Re: Botley West Solar

To the Planning Inspectorate,

Here are some submissions on the proposed Solar Power Station, for your kind consideration.

Roads - B4017

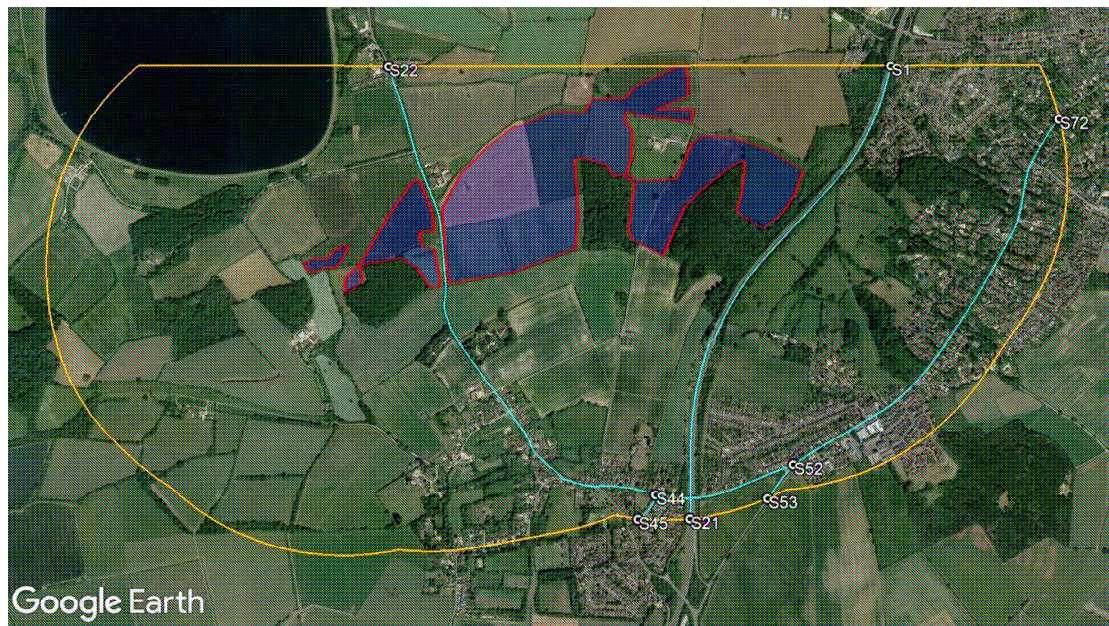
It is clear also that the B4017, where it descends steeply down into the Farmor Valley and then across the floor, through a sea of panels on both side would be exposed to glint and glare. (Blue line S22 to S72)

*Solar reflections geometrically possible from **outside** a road user's primary field-of-view
Existing and/or proposed vegetation is predicted to significantly obstruct views of reflecting panels : No impact, no mitigation necessary.*

I would argue that drivers heads are not clamped in a forward position. They turn to look to the sides of road as good drivers should and also to enjoy the scenery. A flash of light can cause momentary blindness even if it does not come through the windscreen from straight ahead.

The photos underneath show the B4017 and how little the existing vegetation protects the drivers of a selection of vehicles from being dazzled. What is not shown in the photographs is that there are large gaps in the hedges. The hedges are not continuous and have openings into the fields.
